Primary Engineering, Inc.
2828 Lake Ave.
Fort Wayne, Indiana 46805
260-424-0444 ph
www.primary-eng.com

Addendum: **1**
Date: **3/7/2025**
Project: **FWCS HPB Natatorium HVAC Improvements**

Comm #: **24634**

PRIMARY ENGINEERING INC
 Indianapolis
 Fort Wayne
 2828 Lake Ave.
 Fort Wayne, Indiana 46805
 info@primary-eng.com
 www.primary-eng.com

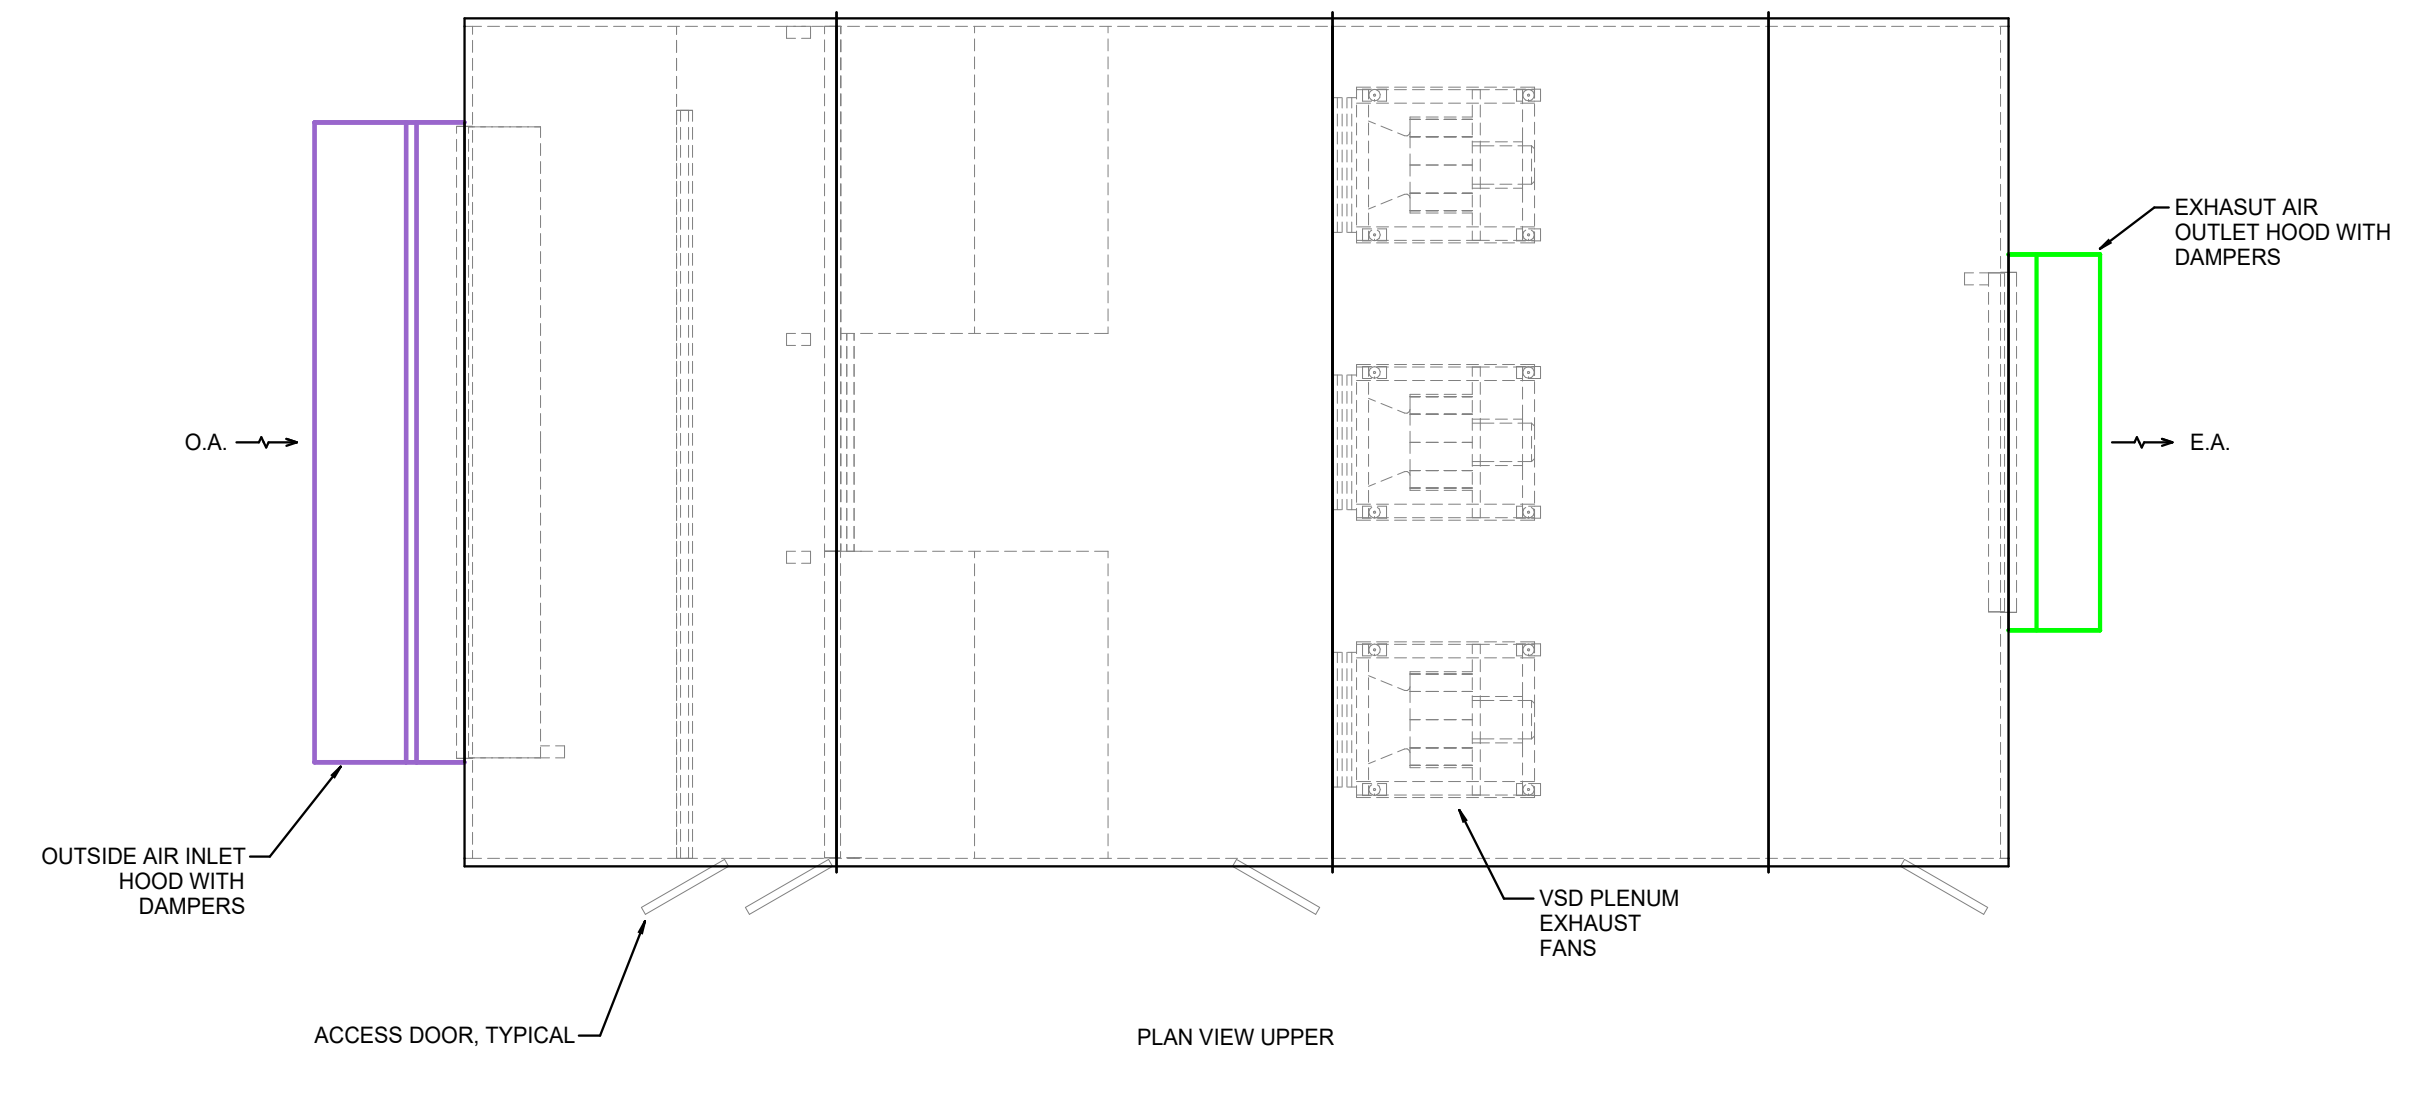
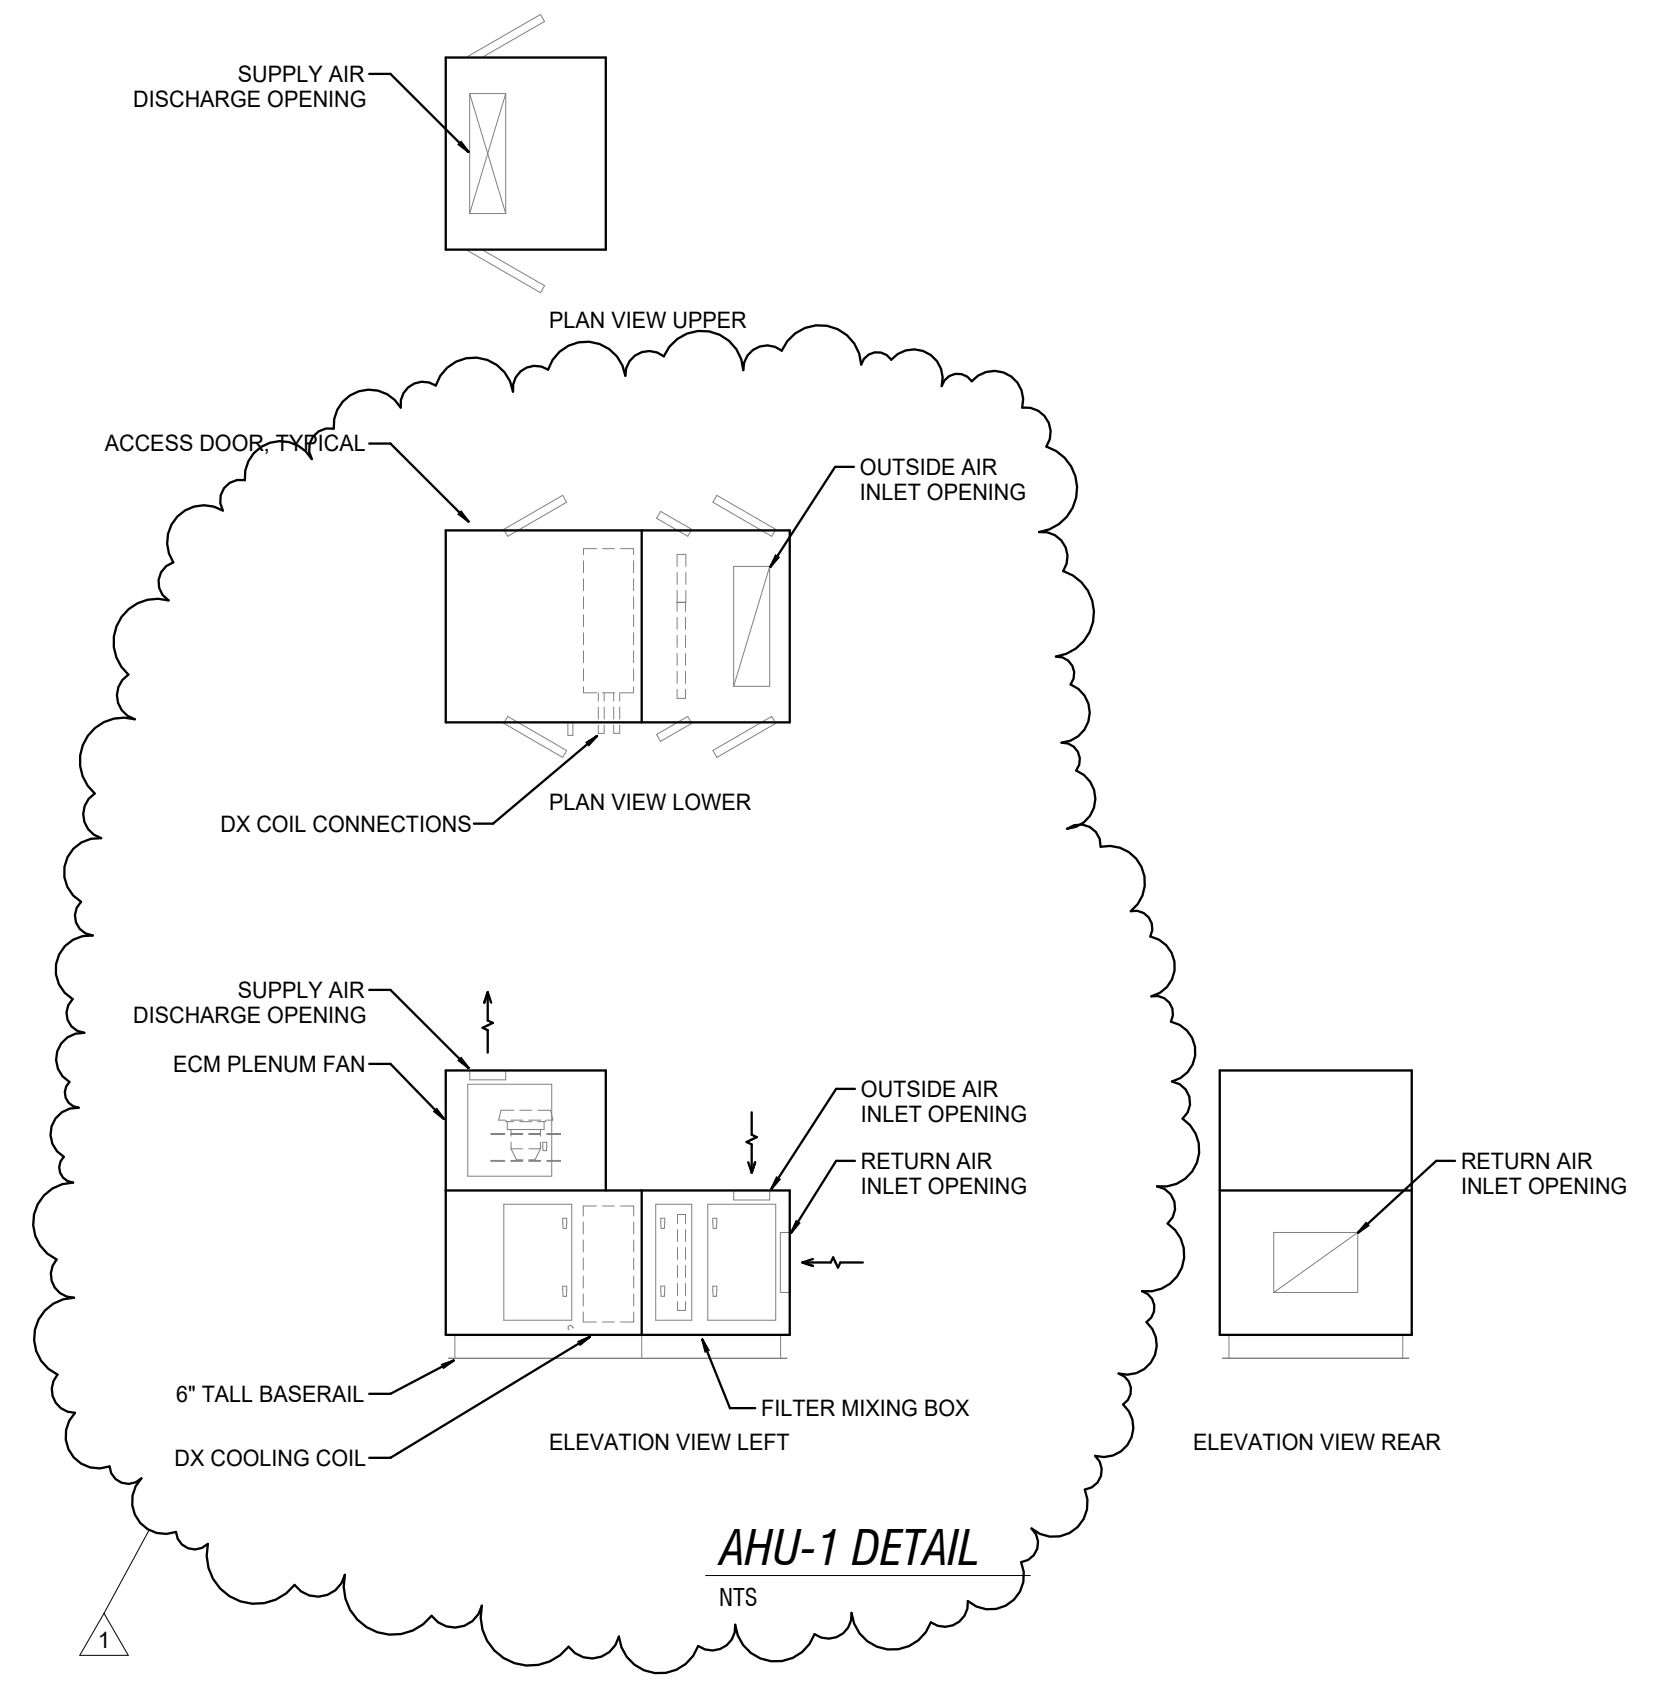
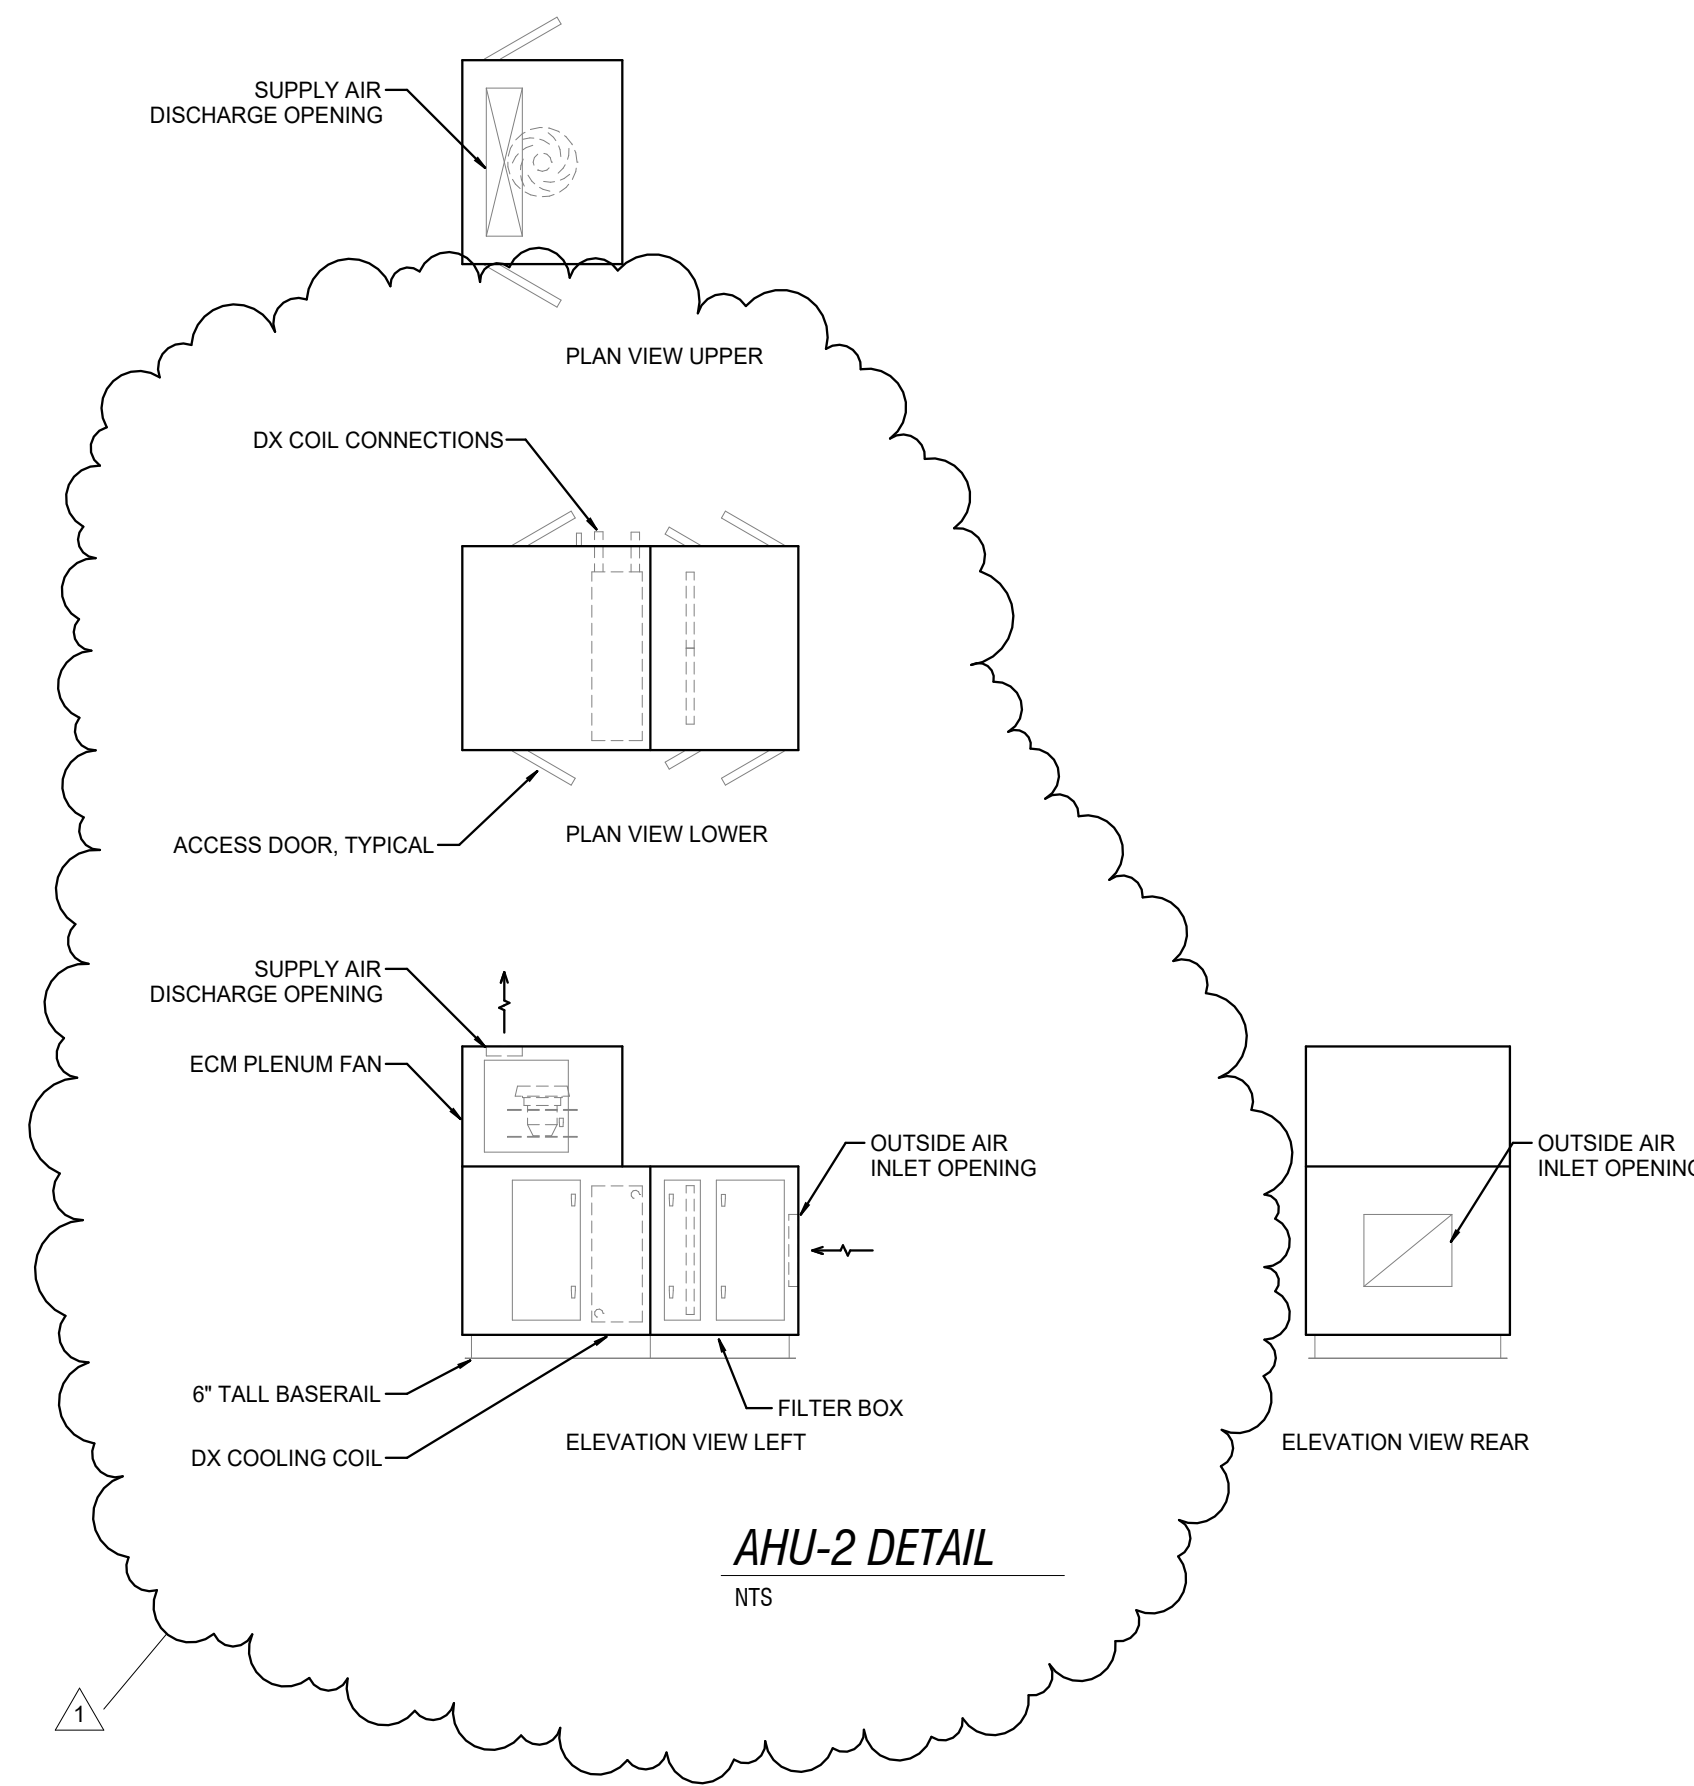
- A. Revise AHU-1 Detail. Revise AHU-2 Detail. See attached drawing revision to M401 dated 3/7/2025.
